<b>PROJECT</b>	:	5 x 800 MW Yadadri TPP
<b>PACKAGE</b>	:	<b>COMPRESSED AIR SYSTEM</b>
<b>ENQUIRY NO</b>	:	E-5927/2018 Dated 07.05.2018
<b>SUBJECT</b>	:	<b>TECHNICAL AMENDMENT</b>

**AMENDMENT ON TECHNICAL SPECIFICATION FOR COMPRESSED AIR SYTEM  
PACKAGE  
5 X 800 MW YADADRI TPS**

SPECIFICATION NO.: PE-TS-417-555-A001

AMENDMENT NO # 2

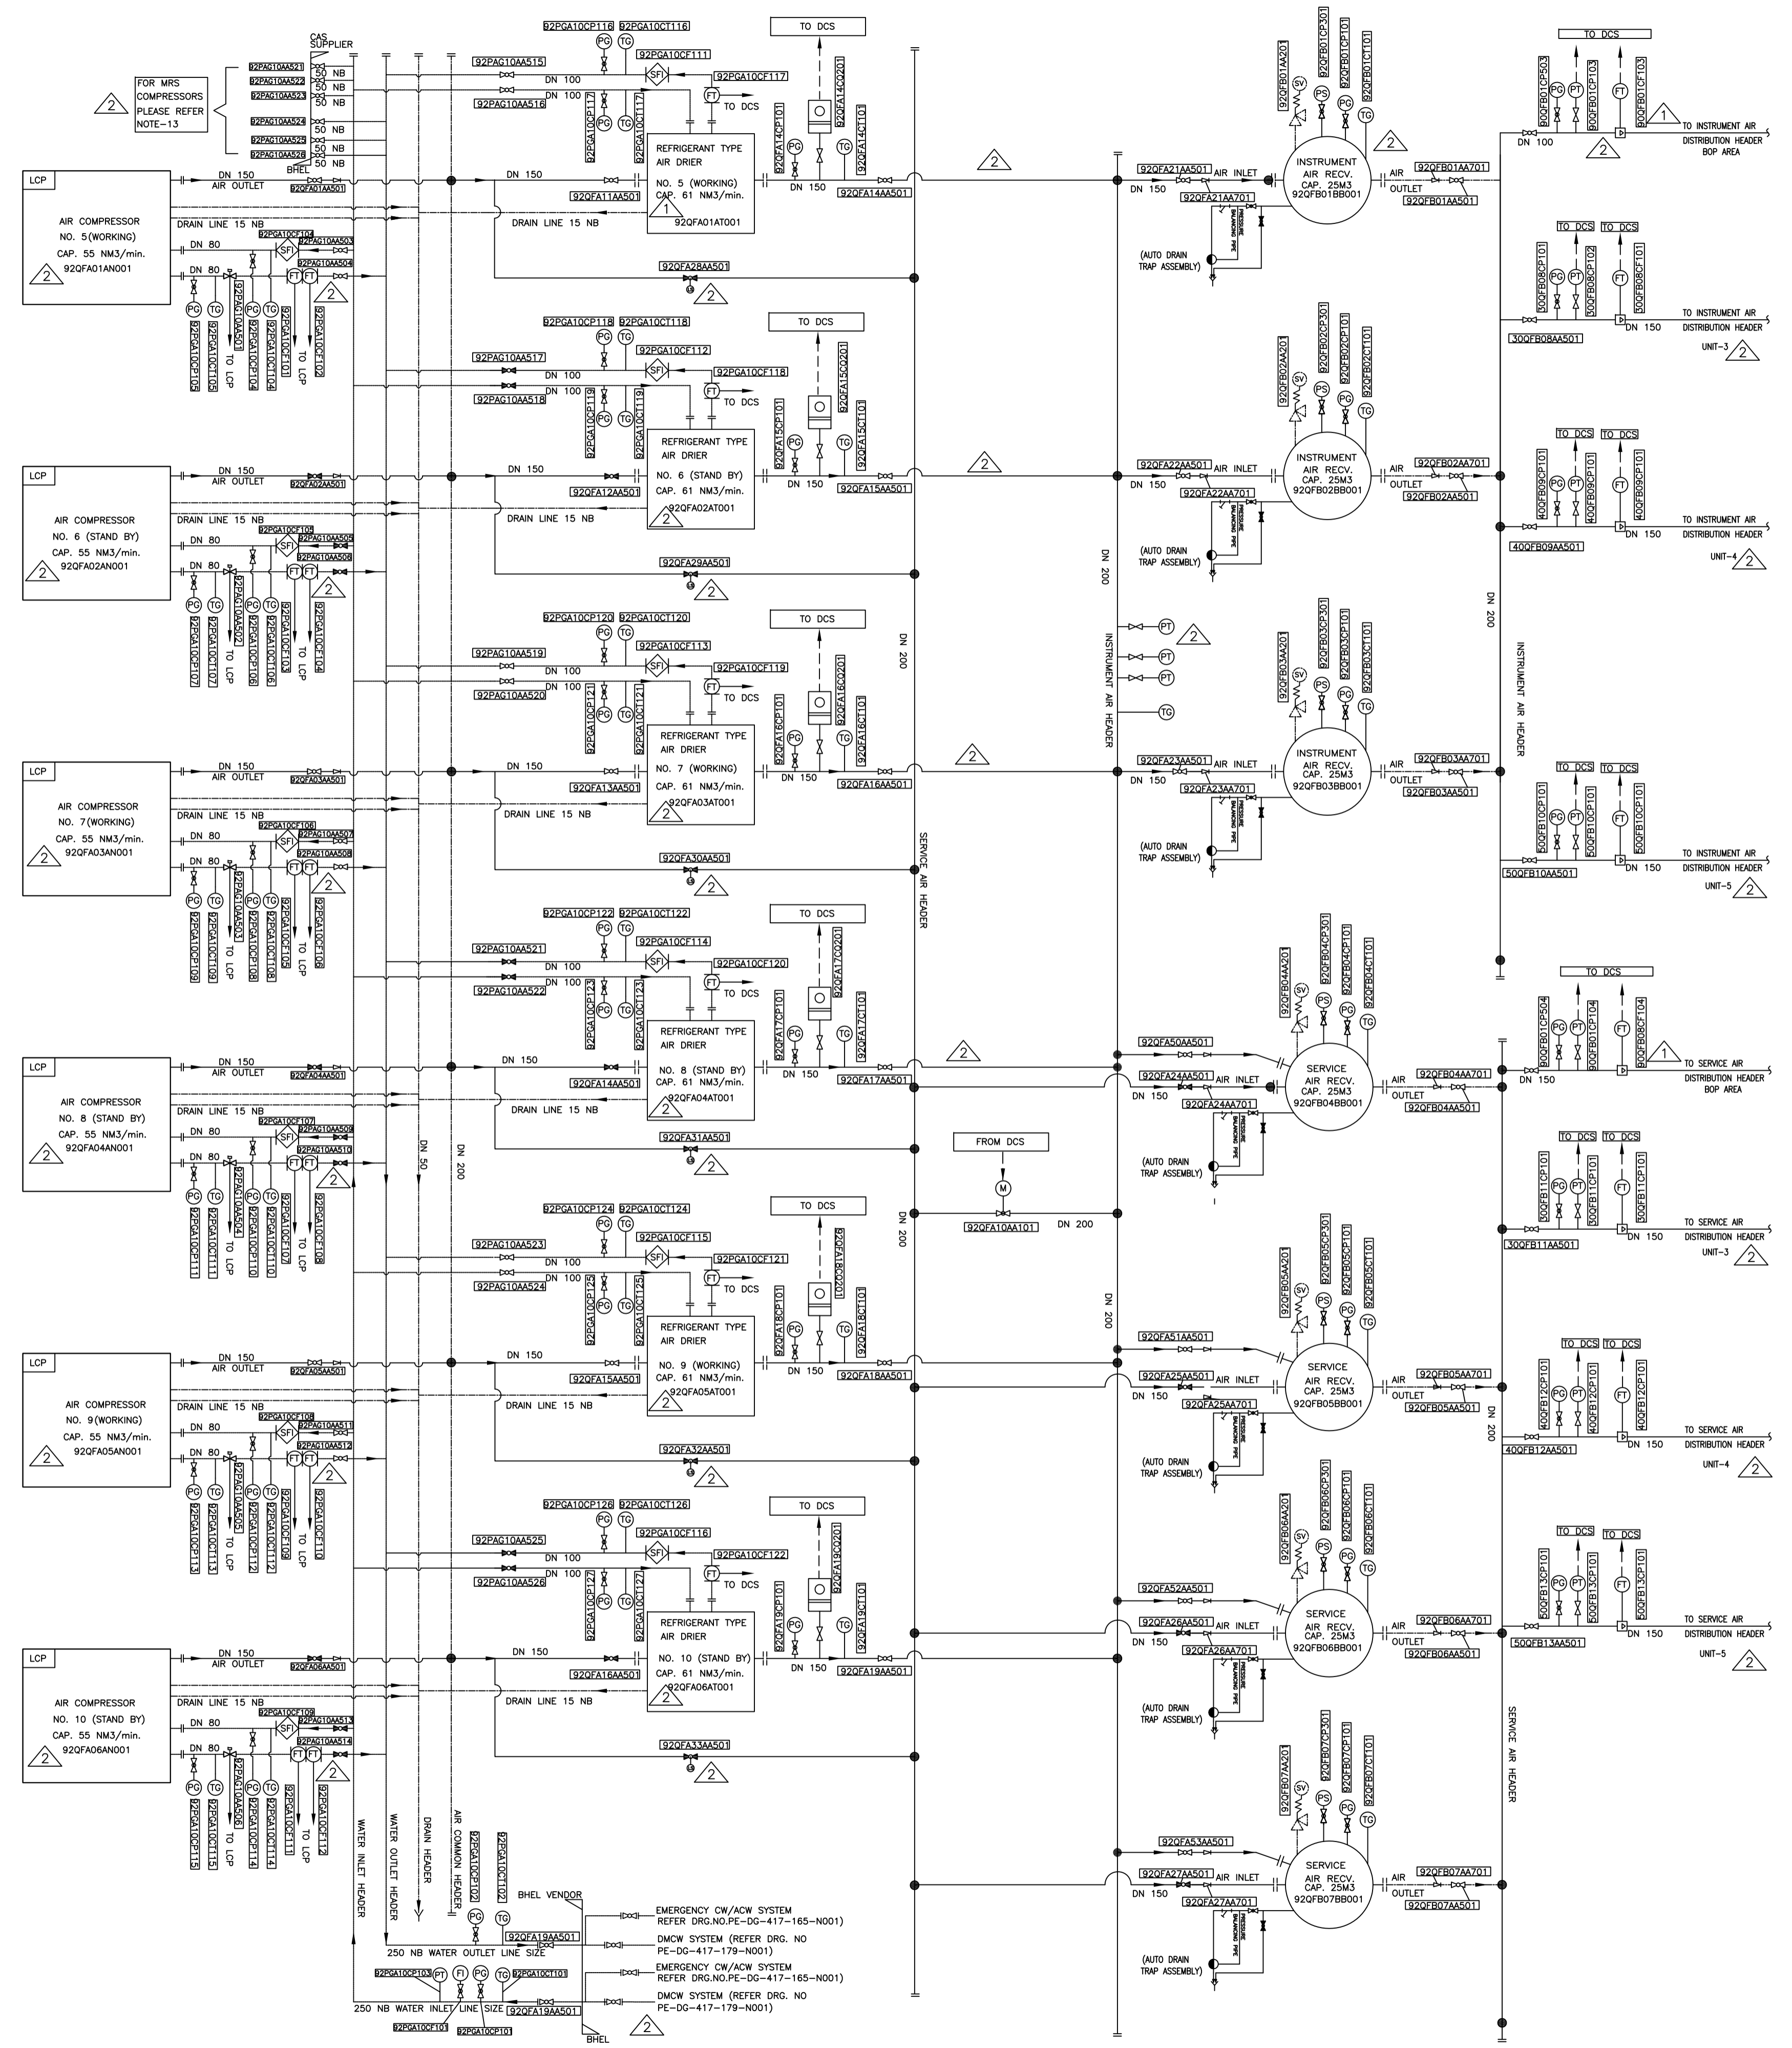
Sl no.	Section	Description	Clause	Page no	Existing clause/details	Modified to or Read as
1.	ANNEXURE-A OF AMENDMENT 1	P& ID of compressed air system within compressor house	--	4,5 OF 23	drawings 1. P& ID of compressed air system within compressor house (PE-DG-417-555-A018, R-01)	1. P& ID of compressed air system within compressor house (PE-DG-417-555-A018, R-02). Revised drgs. are attached as annexure – A
2.	ANNEXURE-B OF AMENDMENT 1	DESIGN MEMORANDUM OF CAS	3.2	13 OF 23	The corrosion allowance shall be 2.0mm.	The corrosion allowance shall be 3.0mm.
